v0.1 Bug record:

| File: IOI.kicad_sch | |

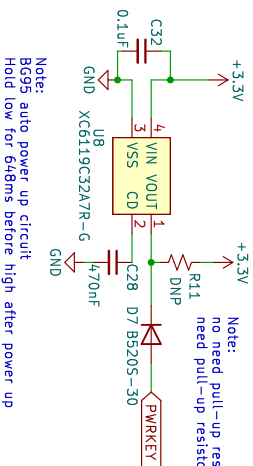
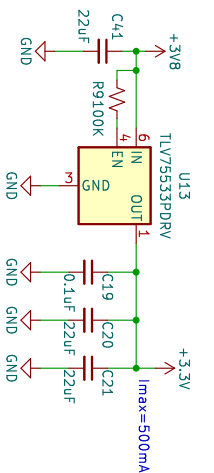
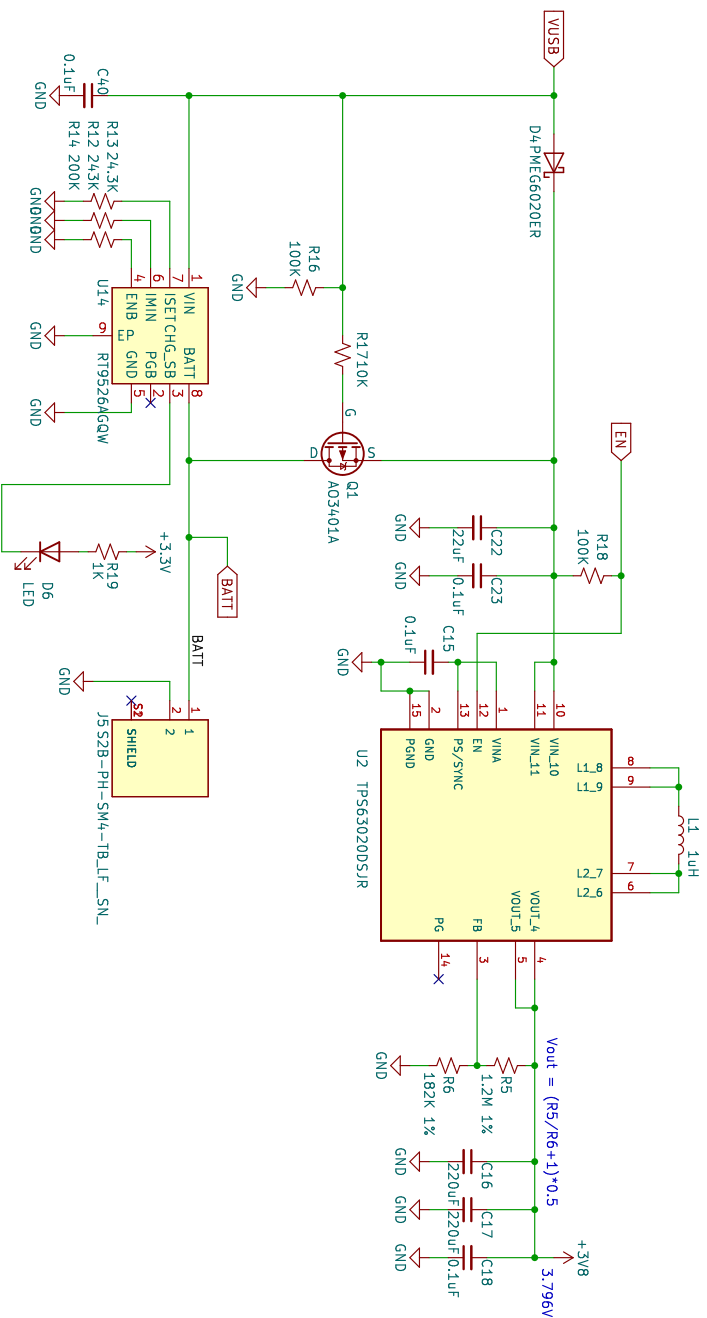
1. CHG_SB need to have a pull-up resistor
2. No pull-up resistors for SDA and SCL line
3. Need a ESD diode for power key button
